UNITED STATES  
NUCLEAR REGULATORY COMMISSION  
WASHINGTON, D.C. 20555-0001

SUBJECT: CALVERT CLIFFS NUCLEAR POWER PLANT UNITS 1 AND 2 – FLOOD  
HAZARD MITIGATION STRATEGIES ASSESSMENT (CAC NOS. MF7908 AND  
MF7909)

STAFF ASSESSMENT BY THE OFFICE OF NUCLEAR REACTOR REGULATION  
RELATED TO MITIGATION STRATEGIES FOR CALVERT CLIFFS NUCLEAR POWER  
PLANT UNITS 1 AND 2 AS A RESULT OF  
THE REEVALUATED FLOODING HAZARD NEAR-TERM TASK FORCE  
RECOMMENDATION 2.1- FLOODING CAC NOS. MF7908 AND MF7909

Figure 3.1.1-1. Schematic of HEC-HMS model, taken from the Amended FHRR (Exelon, 2015).

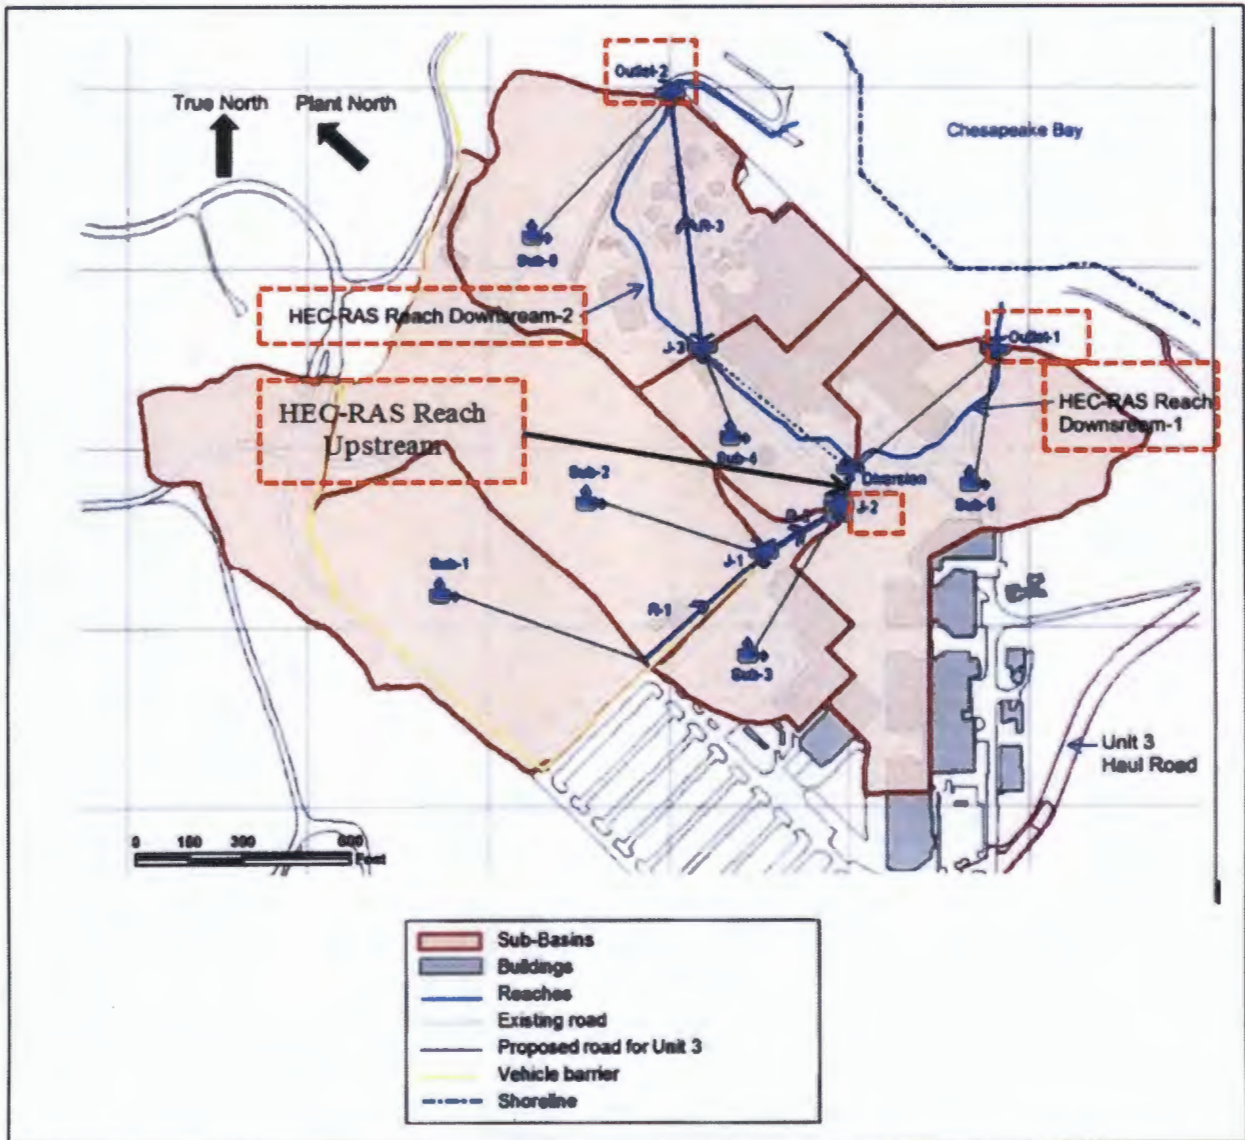
The licensee applied USACE-developed HEC-HMS and HEC-RAS models sequentially to evaluate the LIP flood hazard caused by a LIP flood-causing mechanism. They postulated a 6-hour ssPMP scenario as input to the Calvert Cliffs HEC-HMS model. That is, they distributed the 6-hour ssPMP value into 5-minute, 15-minute, 1-hour, 2-hour, 3-hour, and 6-hour intervals for input to the model (see Table 3.2.0-1). They used a front-peaking distribution in time. To set up the Calvert Cliffs HEC-HMS model, the licensee divided the onsite LIP basin into 6 subbasins and then linked the subbasins by channels as shown in Figure 3.1.1-1.

Figure 3.1.1-2. Schematic of the HEC-RAS hydraulic model for simulating the LIP flood-causing mechanism.

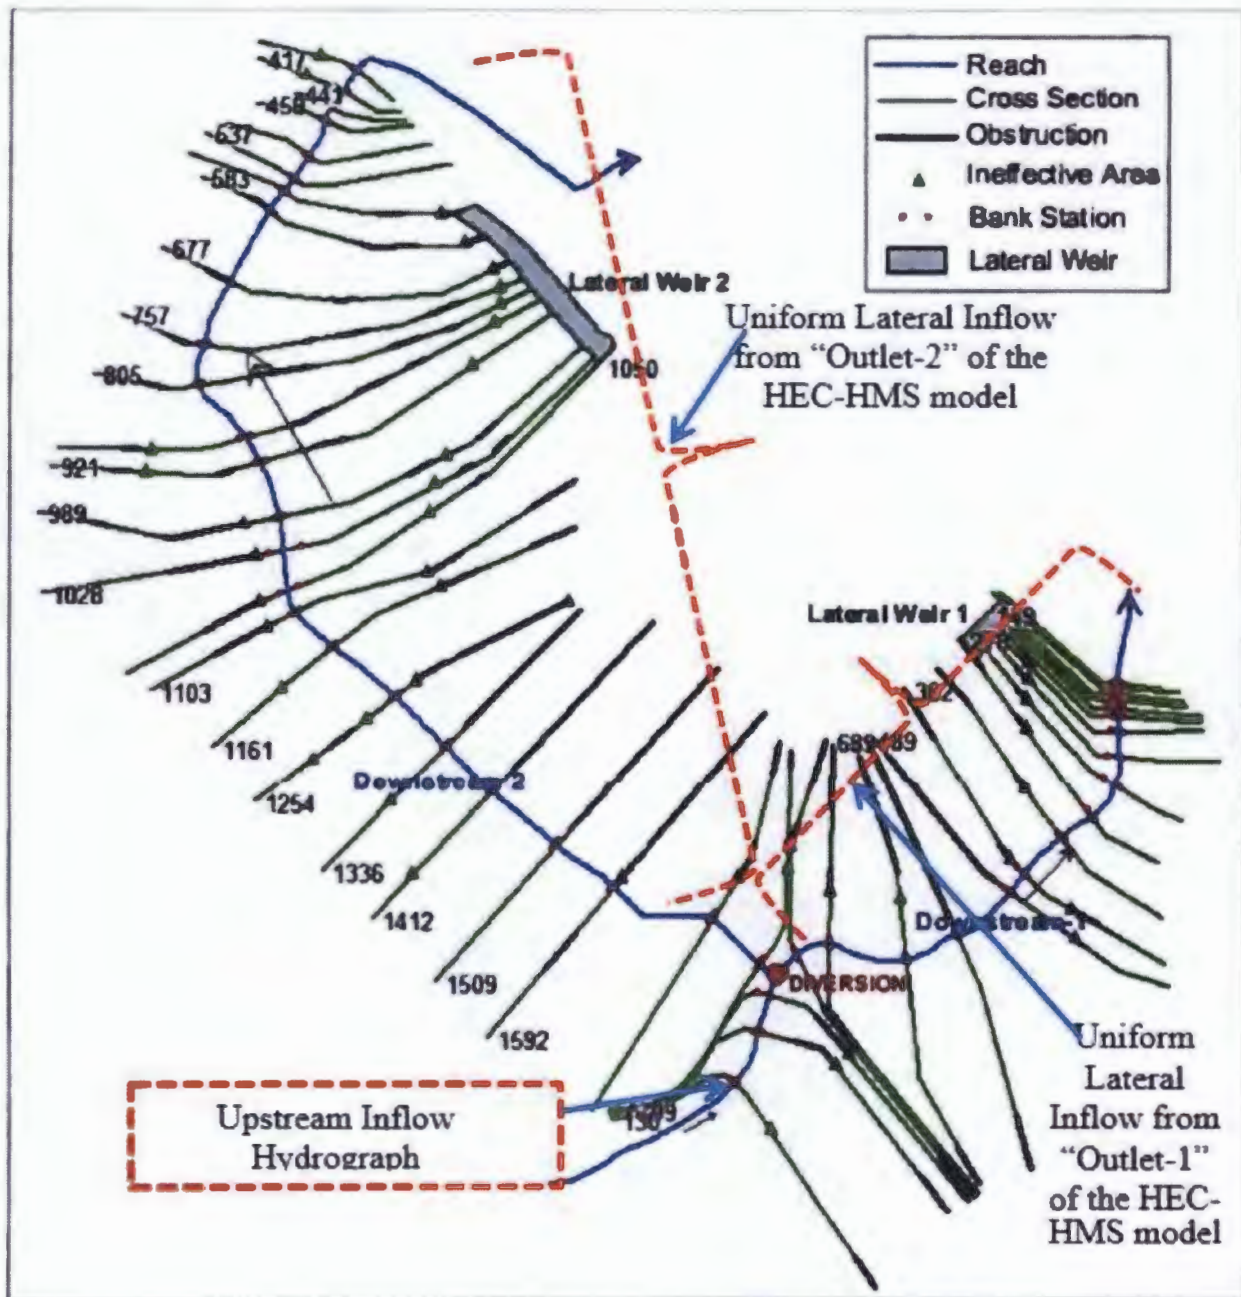
As described in its original FHRR, the licensee used the HEC-RAS model to route flood elevations at the Calvert Cliffs Units 1 and 2 power block area. The main features of the HEC-RAS are onsite drainage channels and cross-sections (see Figure 3.1.1-2). The licensee used the simulated outflow flow hydrographs from the HEC-HMS at locations, "J-2", "Outlet-1", and "Outlet-2" as upstream inflows to channels in HEC-RAS.

Figure 3.1.2-3. Postulated PMH scenarios for (a) track direction (top) and (b) distance from the plant site to storm center (bottom) (from Exelon (2017)).

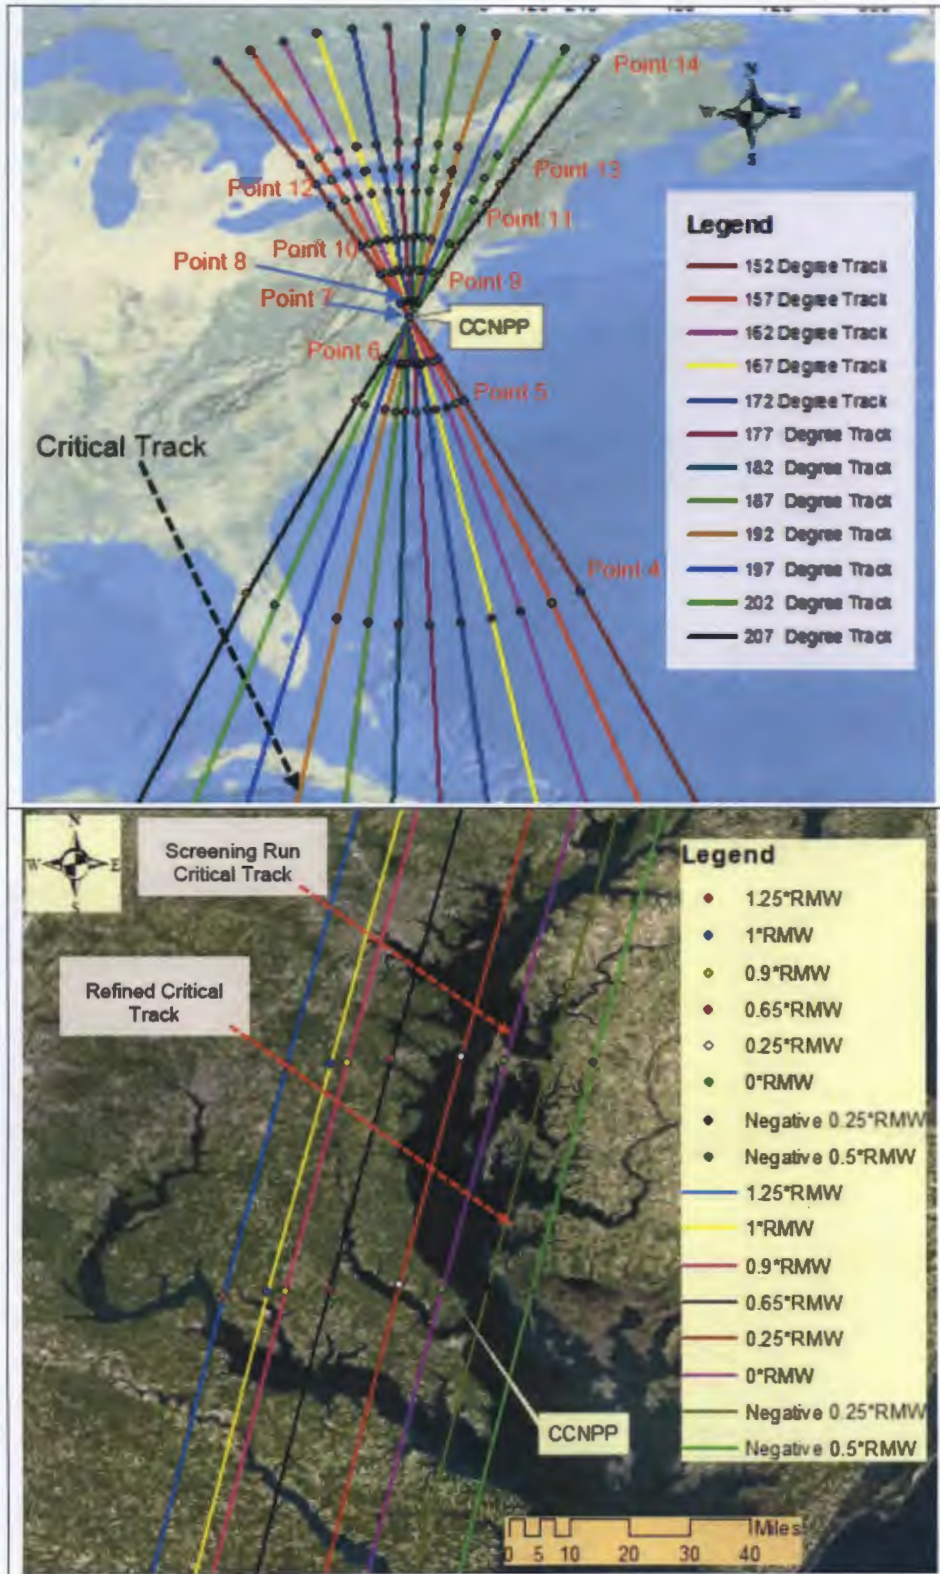
- i. Hold the pressure deficit of 123 milibar (mb) which is the maximum, and synchronize the timing of the storm surge with incoming high tide.
- ii. Simulate the Calvert Cliffs Delft 3D model with 10 track directions (152, 157, 162, 167, 172, 177, 182, 187, 192, and 197 degrees clockwise from the north) with an initial RMW of 26 nm, forward speed of 17 m/s, and center distance of zero from the plant site. From these sensitivity runs, the licensee identified the track direction of 192 degrees as it produces the maximum surge level (see Figures 3.1.2-3a and 3.1.2-4a).

- v. Simulate 8 center distances (1.25, 1.0, 0.65, 0.25, 0, -0.15, -0.5, -0.25 times RMW (see Figure 3.1.2-3b)), where positive value means storm center is shifted to the left from the site, while negative is to the right. The licensee selected -0.25 times RMW (0.25 times radii to the left) as an optimal (see Figures 3.1.2-3b and 3.1.2-4d).

Figure 3.1.2-4. Delft3D storm surge sensitivity for (a) track direction for top-left, (b) RMW for top-right (c) forward speed for bottom-left, and (d) storm track for bottom right (from Exelon(2017)).

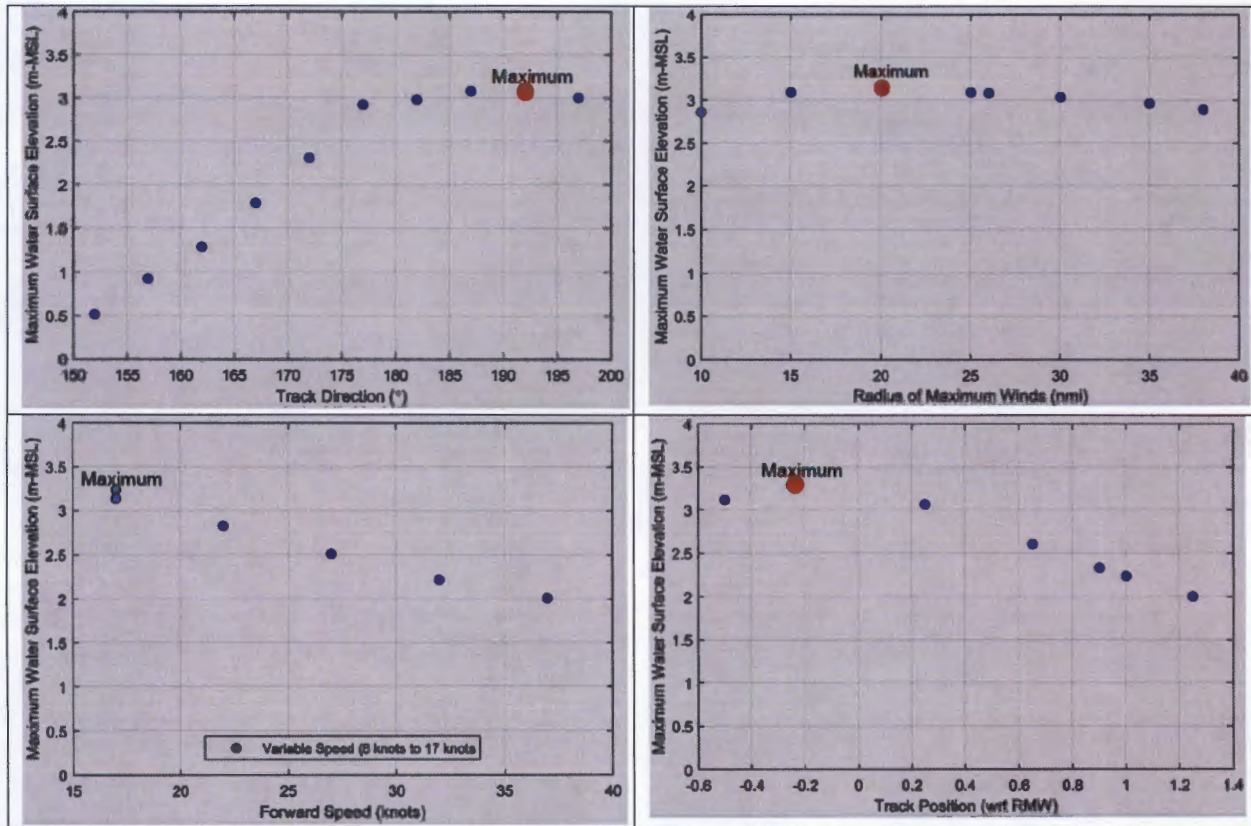
- iii. Simulate the model with 8 RMWs (10, 15, 20, 25, 26, 30, 35, 38 nautical miles (nm)) with the storm direction of 192 degree, forward speed of 17 m/s, and center distance of zero. The radius of maximum wind sensitivity was extended beyond the range presented in NWS 23 to determine if hurricanes with larger RMWs increase the surge level at the plant site. From these runs, the licensee determined an optimal RMW of 20 nm (see Figure 3.1.2-4b).

- iv. Simulate the model with 6 storm forward speeds (17, 22, 27, 32, 37, and variable speed of 8 and 17 knots (kt)) with the storm direction of 192 degree, RMW of 20 nm, and center distance of zero. The licensee-identified combined forward speeds of 8 kt before landing and 17 kt after landing turned out to be optimal (see Figure 3.1.2-4c).

Table 3.1.2-1 lists the licensee-provided optimal PMH parameter values from the resulting of the screening. Figure 3.1.2-4 displays the results of the sensitivity analysis, where each plot forms clear surge level peaking for most of the parameters. As the rates of changes at the peak are insignificant (e.g., mostly less than a foot), the staff determined the discrete parameter intervals used in the licensee's screening is acceptable without further refining the parameter values at finer discrete intervals. In particular, the staff noted onsite surge level is less sensitive to the change of RMW values compared to those at open coastal sites. The staff believes this is due to the breaking and attenuation of offshore surge and wave, as the plant site is located approximately 80 miles inside from the mouth of the Chesapeake Bay.

The staff also noted the licensee's selection of 20 nm RMW storm is based on a single "base" track that goes over site, even though it is within the range provided by NWS 23. That is, the sensitivity to RMW parameter was not checked for multiple storm tracks, angles, and landing locations. For example, the licensee settled on the 20 nm RMW value with a simple track (landfall and angle) that may not produce the maximum water level at the plant site. The staff also recognized the screening could be improved further by refining the PMH parameter values, such as using RMW values at the 1nm resolution or track positions at the finer (e.g., 0.1 times RMW) resolution. These refinements would end up a higher surge level estimates than the ones presented by the licensee in the amended FHRR. To resolve this issue, the staff found from Figure 3.1.2-4 that the change of surge level at or near optimal RMW (e.g., 20 nm) is small for those initial "base" runs (e.g., much less than one foot per discrete interval tried), and that the same is true for other PMH parameters. Therefore, the staff determined the result of the licensee's screening is acceptable without further refining the parameter intervals. In all, the staff concludes the screening process to obtain site-specific PMH parameters is reasonable and the resulting PMH parameters are acceptable for use in the MSA as the licensee followed a hierarchical approach recommended by the guideline provided in NUREG/CR-7046 Appendix E (NRC, 2011).

Figure 3.1.2-7. Cross Section Schematic of Wave Activity on Pump House at Calvert Cliffs Units I and 2 House (from the amended FHRR, Figure 2.4-32).

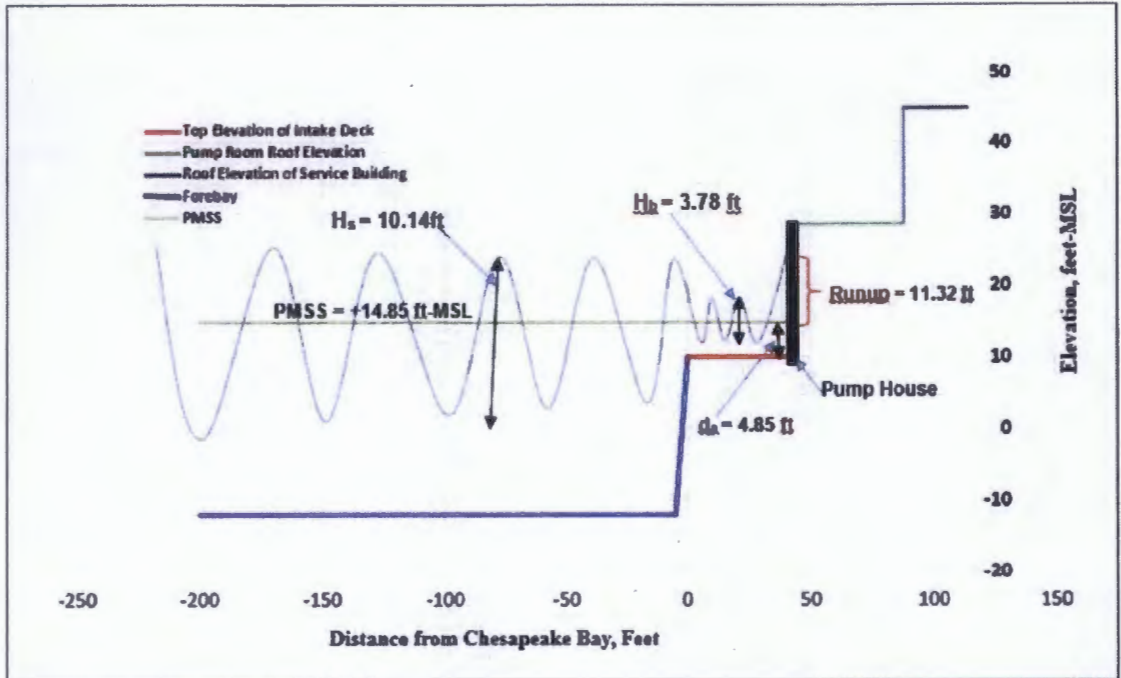
The licensee estimated storm surge-induced wave runup at the Units 1 and 2 Intake Structure (Exelon, 2015). The licensee assumed that runup occurs when wind-generated wave moves over the top of the intake deck and hits the front wall of the Intake (see Figure 3.1.2-7). They determined the controlling depth of water on the deck is 4.85 ft. The controlling depth limits the wave height over the deck as the break of large waves may occur in front of the deck. The licensee determined a maximum wave height after break is equal to 3.78 ft. using a depth limiting constant of 0.78 (Exelon, 2015). The licensee estimated runup values using the following two methods described in Army Corps of Engineering (USACE) Coastal Engineering Manual (CEM) (USACE, 2011):

For the equivalent slope method, the staff assumed the step-like intake deck cross section from the toe of the deck to intake wall is idealized as an impermeable slope. With the deck height of 10 ft. and length to the wave direction of 50 ft., the staff estimated an equivalent slope of 17.2 degree using the guideline provided by the CEM (USACE, 2011). The staff's independent calculations demonstrates that the licensee-estimated wave runup values are within the range of the staff's values even though the licensee used different runup conditions and exceedance probability level. Therefore, the staff concludes the licensee's runup estimate is acceptable for use in the MSA as they followed the guidelines provided by USACE (2011).
